NEW ELEMENTARY SCHOOL
9801 HIGHLAND KNOLLS DR
BAKERSFIELD
CALIFORNIA
93306
NEW MIDDLE SCHOOL
4115 VINELAND ROAD
BAKERSFIELD
CALIFORNIA
93306

JOB NUMBER:
20101244
CAD DRAWING FILE:
DRAWN BY:
AC
CHECKED BY:
PH
CHECK AND VERIFY ALL DIMENSIONS BEFORE
PROCEEDING WITH THE WORK.
REPORT DISCREPANCIES TO THE ARCHITECT.
THE DRAWINGS, IDEAS, AND DESIGNS
PRESENTED ON THIS SHEET ARE THE
PROPERTY OF THE ARCHITECT.
COPYRIGHT
ORDIZMELBY ARCHITECTS, INC. 2010
SHEET TITLE
LIGHTING PLAN
BUILDING E
SHEET IDENTIFICATION NUMBER
E-132E
SHEET OF

RFI 163

LIGHTING PLAN BUILDING E

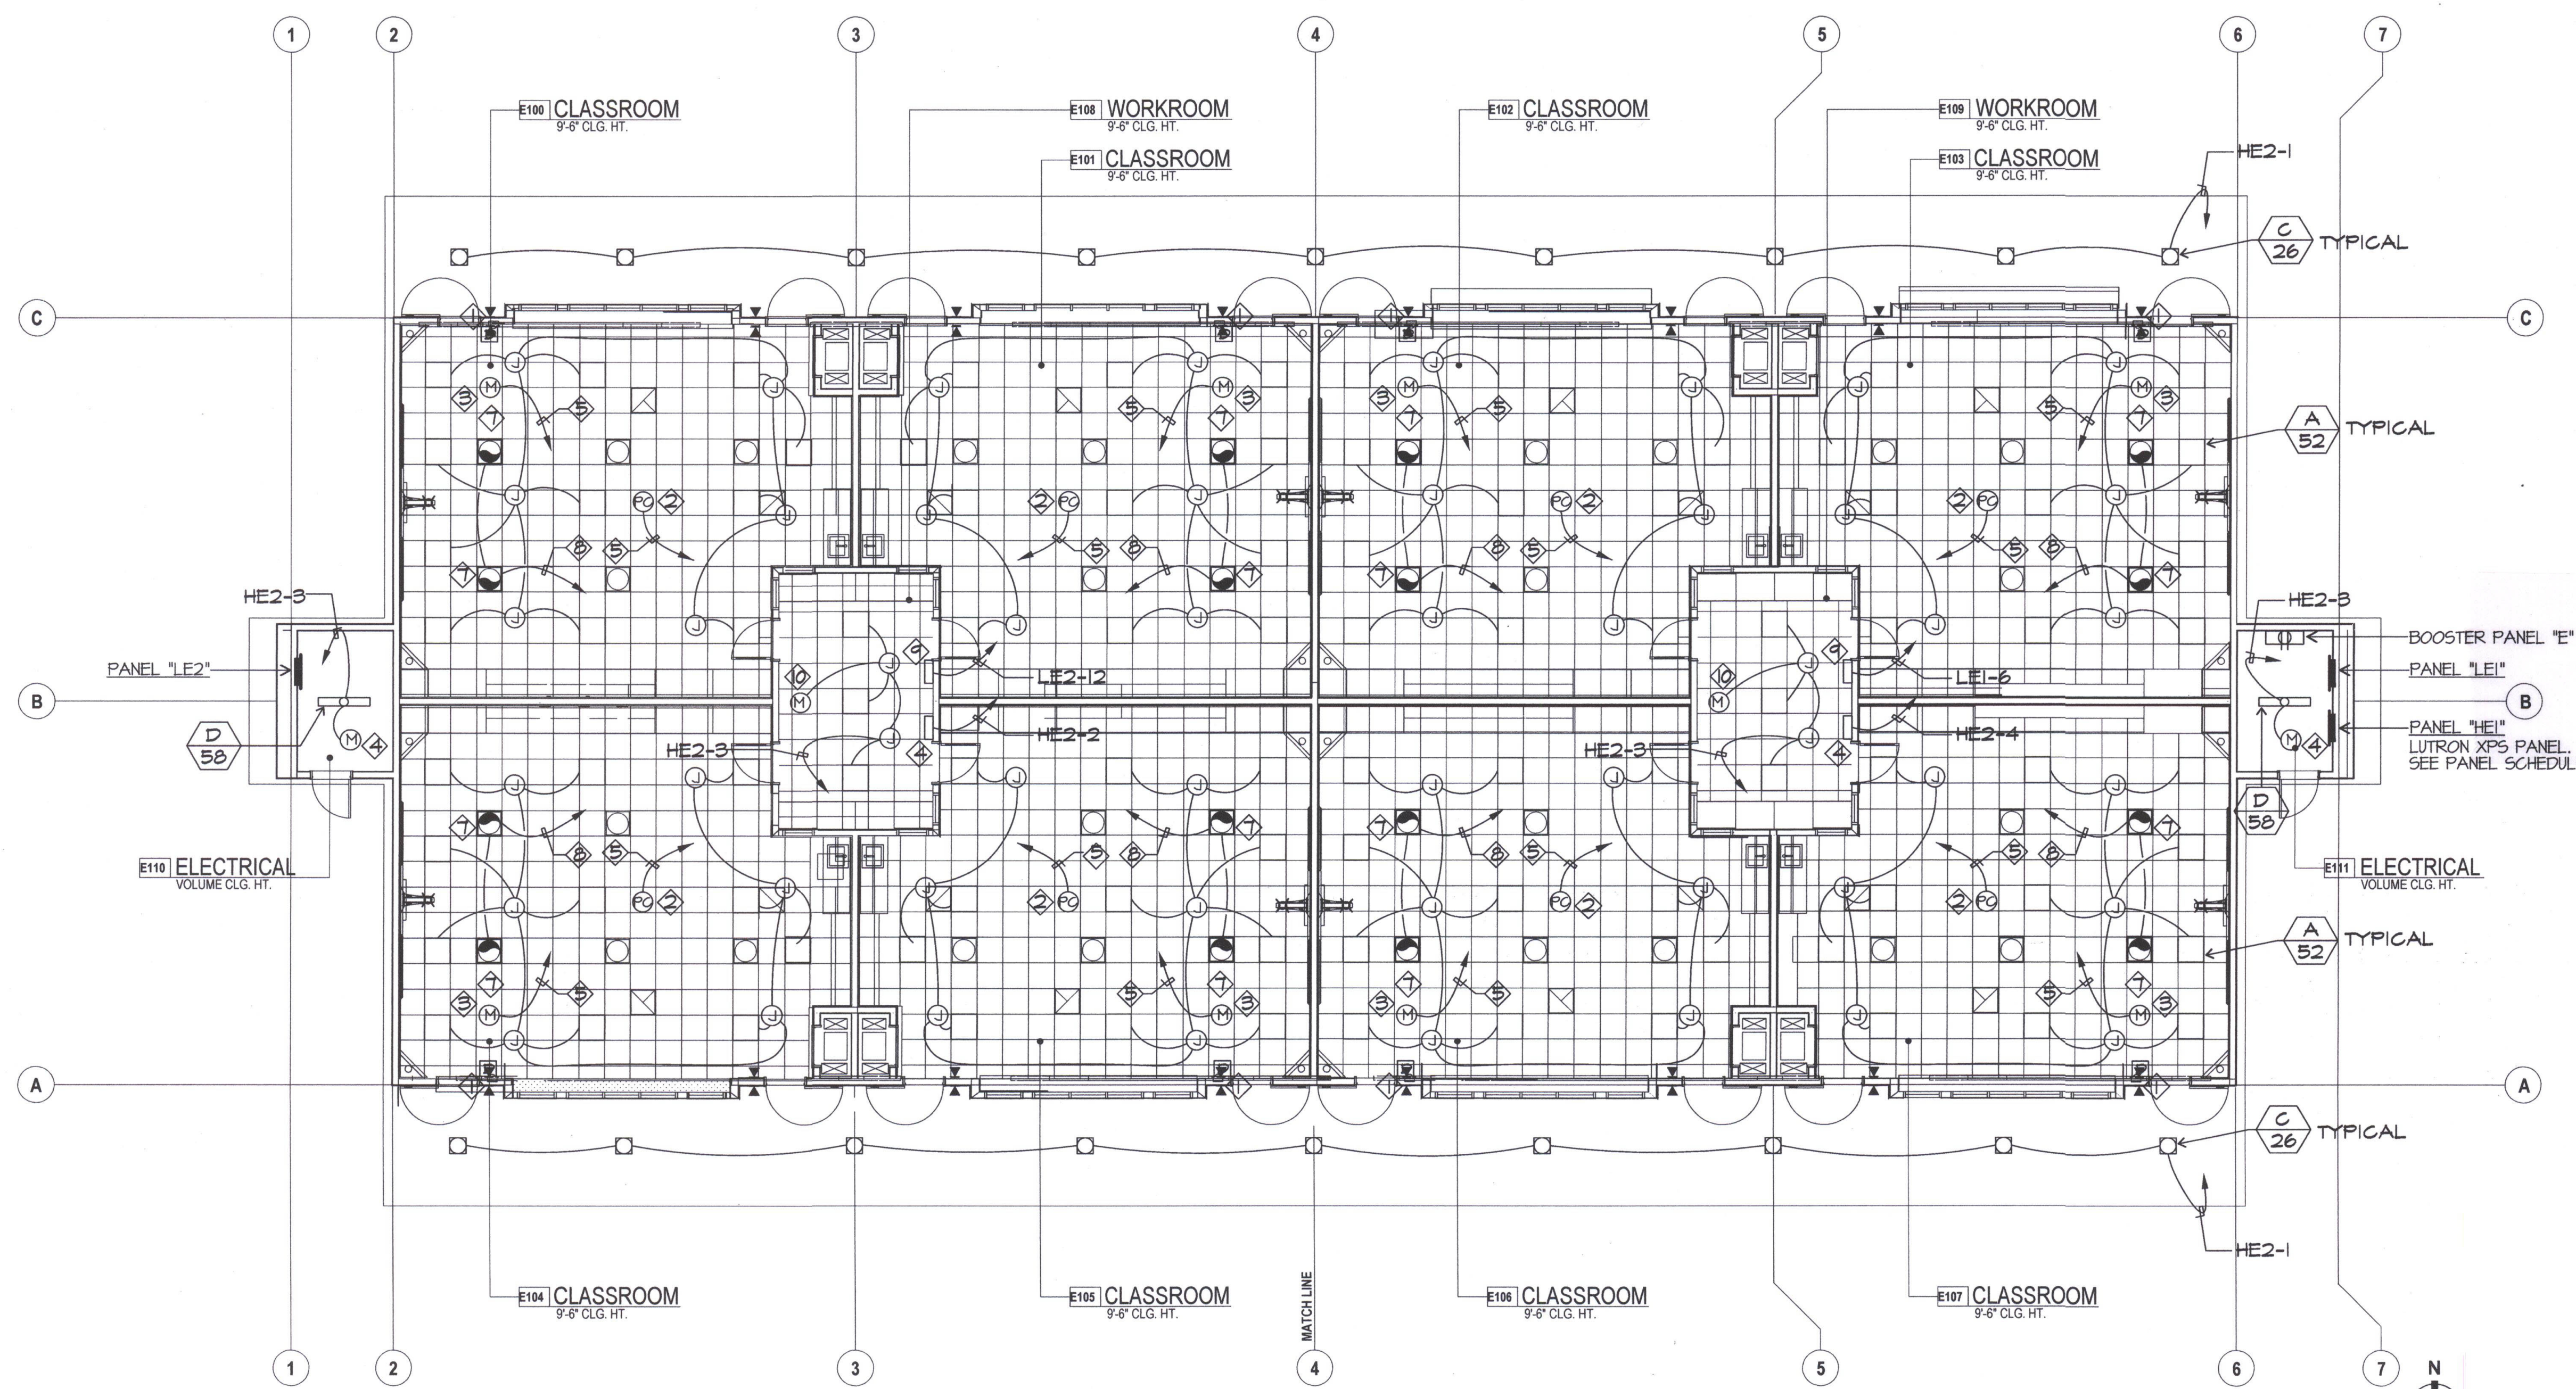
Request:
RDM Electric - 10/9/12
Reference Sheets E-000, E-132C, E-132D, E-132E, E-132F, E-132G, E-132H, E-132P & Lighting Submittal
The General Notes on the Electrical Plans show the lighting dimmers to be installed for the lighting at +42" to top of box and the light switches to be installed at +42". A 5-button Lutron wall station is shown to be installed for the lighting controls in the classrooms. Please provide mounting height (elevations) for the classroom lighting control wall stations.

RFI 163
RDM Electric - 9/18/13
Reference RFI #202 & Sheets E-132C, E-132D, E-132E, E-132F, E-132G, E-132H, E-132P & E-132Q
For the response to RFI #202, the switches in the classrooms are to be controlled via an Energi Savr Node. However, per the attached cut sheets, the switches appear to need separate O.C. switching to the controls, which is not shown on the drawings. The plans only show to supply 120V to the switches via the Energi Savr Nodes. Do the classrooms need O.C. switching to be added as a means of controlling the switches? If so, please advise on the requirements.

Answer:
Joseph W. Covington - Ordiz Melby (10/12/12)
Install all switches and dimmers at +42" to the center of the box.

John Maloney - JMPE - 9/18/13
Contact closure on Energi Savr Node will operate skylight shutter. We verified this with Submittal and Lutron.
